TECHNICAL MEMORANDUM 001
CITY COUNCIL MODIFICATION
NEW YORK BLOOD CENTER—CENTER EAST
CEQR No. 21DCP080M
ULURP Nos. C210351ZMM, N210352ZRM, C210353ZSM
November 16, 2021

Technical Memorandum 001: New York Blood Center—Center East

Reduced Height Building — Illustrative Sections
Figure 1

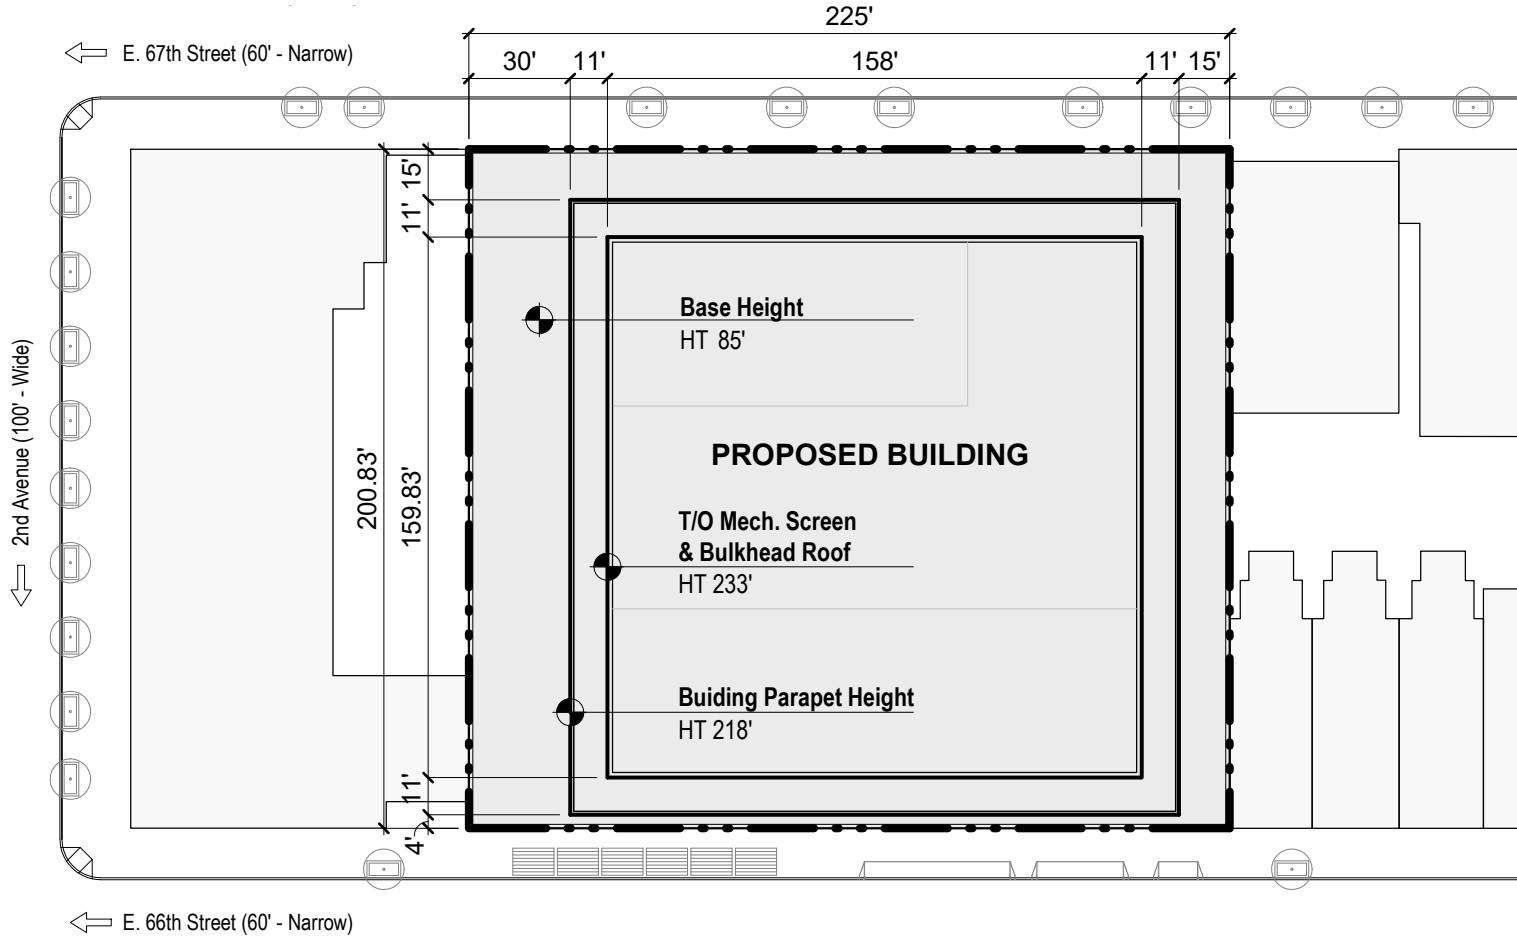
Revisions to the Proposed Project to create the Reduced Height Building and incorporated in the revised ULURP drawings include the following (see **Figures 1 and 2** and Table 2):

- A reduction in the maximum height of the building from approximately 334 feet to the top of the screen wall to approximately 233 feet to the top of the screen wall.
- A reduction in the gross floor area from 596,200 gsf to 527,122 gsf.
- A restrictive declaration will be imposed that will limit the height of an as-of-right building on the site, built pursuant to the C2-7 zoning regulations, to a maximum of 80 feet, not including exterior, enclosed, or screened mechanical equipment, stair, and elevator bulkheads, house tanks, generators, skylights, energy conservation equipment, green roof treatments, and similar rooftop features which may extend an additional 35 feet in height.

The Reduced Height Building would have the same characteristics as those described for the Proposed Building analyzed in the FEIS, except that the Reduced Height Building would have lower floor-to-floor heights and a consolidated mechanical footprint at the top of the building. Typical floor-to-floor heights would be reduced from 16 feet to 14.5 feet with similar reductions on atypical floors, which was achieved through refinements in the mechanical systems design and planning. Additional height reduction was achieved by eliminating usable building area: a reduction of approximately 20,000 to 69,000 community facility gsf and of approximately 0 to 51,000 commercial gsf, as compared to the Proposed Building shown in Table 2. The Reduced Height Building includes a range of potential community facility and commercial gsf because the Applicant is still determining how best to allocate the reduced building square footage between the building’s uses. Compared to the Proposed Building analyzed in the FEIS, the Reduced Height Building would result in a reduction in the number of employees from 2,630 to between 2,280 and 2,514.

Reduced Height Building — Shadows
March 21/September 21

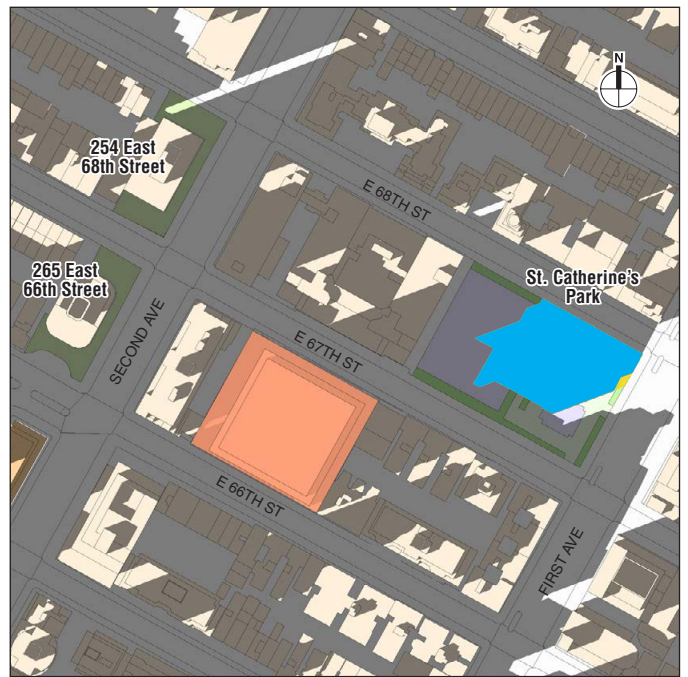
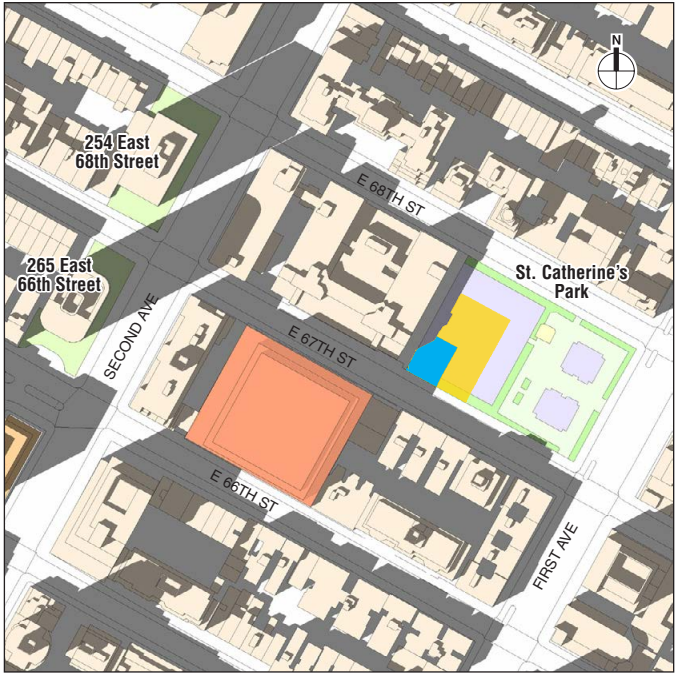
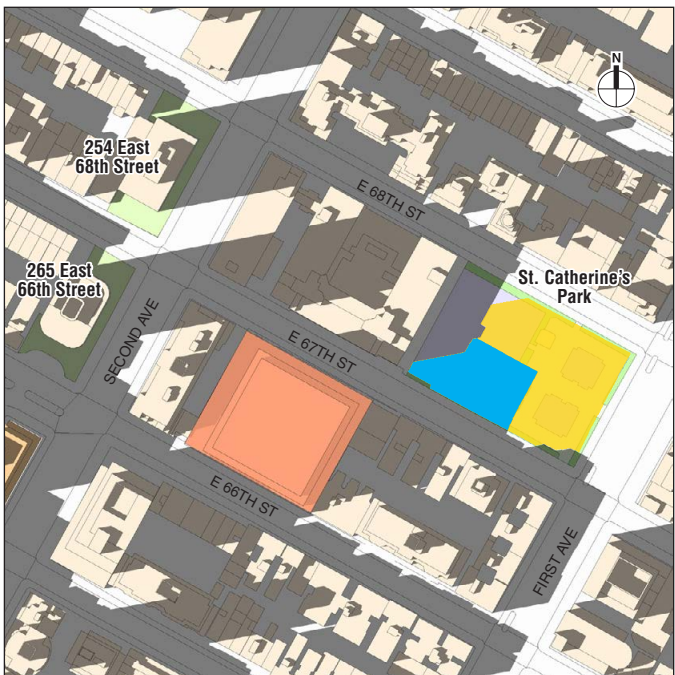
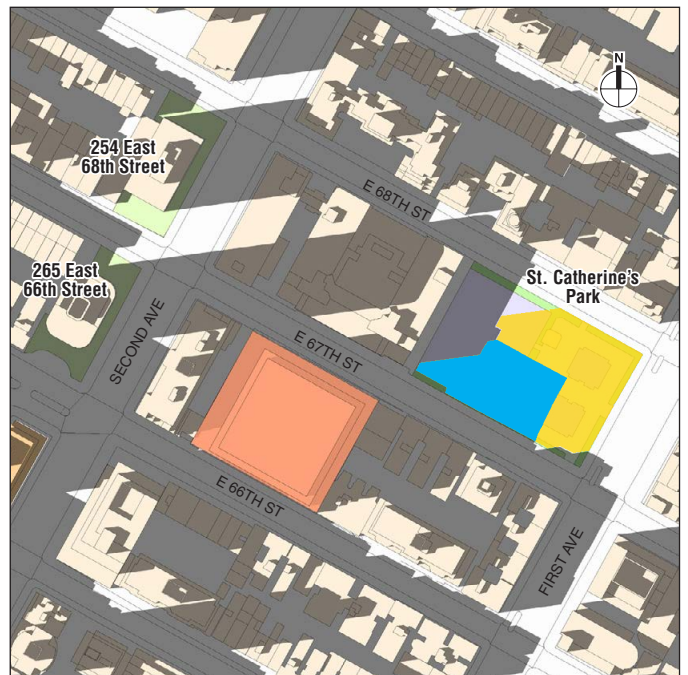
With the Reduced Height Building, incremental shadow would enter the western edge of the park (i.e., the western edge of the paved ball courts) at 2:00 PM (3:00 PM EDT), 15 minutes later than the Proposed Project analyzed in the FEIS. At any given time throughout the afternoon, the

incremental shadow would cover a smaller proportion of the park compared to the Proposed Project, as shown in **Figure 5**, until about 4:00 PM (5:00 PM EDT), after which the incremental shadow would be the same as with the Proposed Project until the end of the analysis day about 30 minutes later. With the Reduced Height Building there would be no incremental shadow on the eastern half of the park (containing playgrounds and seating areas) until 3:20 PM (4:20 PM EDT), whereas with the Proposed Project, shadow would enter the eastern half approximately 35 minutes earlier at 2:45 PM (3:45 PM EDT).

Reduced Height Building — Shadows
May 6 / August 6

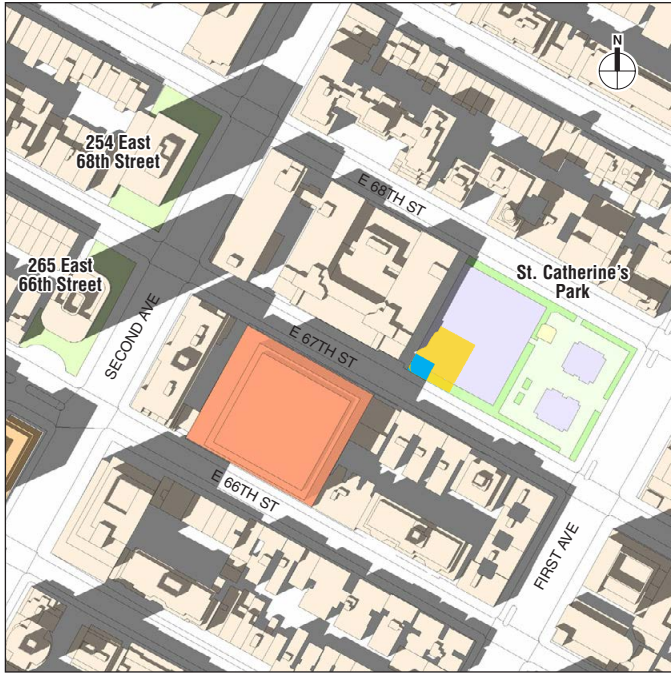
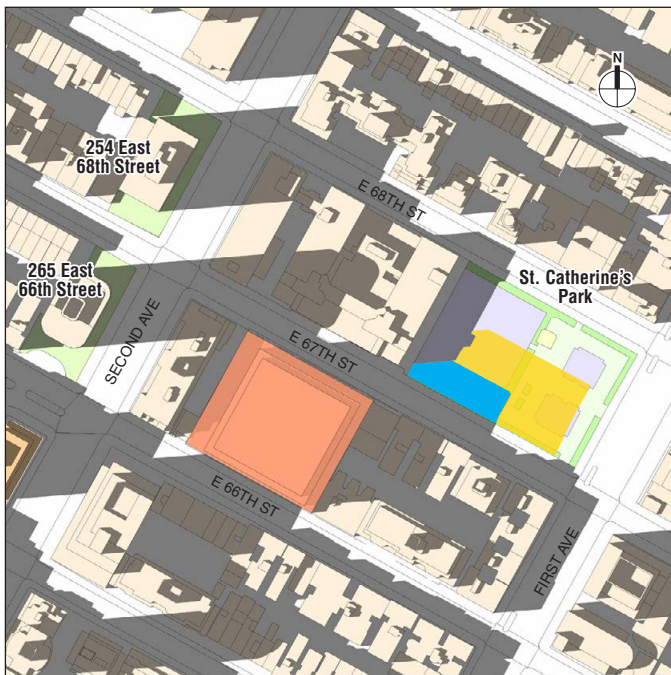
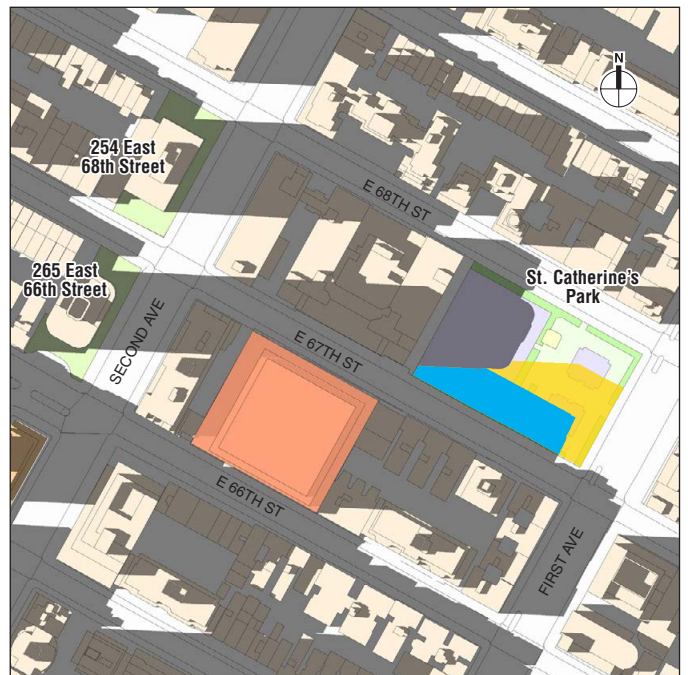
With the Reduced Height Building, incremental shadow would enter the western half of the park (the paved ball courts) at 1:35 PM (2:35 PM EDT), 15 minutes later than the Proposed Project analyzed in the FEIS. At any given time throughout the afternoon, the incremental shadow would cover a smaller proportion of the park to the Proposed Project, as shown in **Figure 6**, until about 5:00 PM (6:00 PM EDT), after which the incremental shadow would be the same as with the Proposed Project until the end of the analysis day about 20 minutes later. At times, such as 3:30 PM (4:30 PM EDT), the size of the incremental shadow would be substantially smaller. With the Reduced Height Building there would be no incremental shadow on the eastern half of the park (containing playgrounds and seating areas) until 3:20 PM (4:20 PM EDT), whereas with the Proposed Project shadow would enter the eastern half approximately 45 minutes earlier at 2:35 PM (3:35 PM EDT).
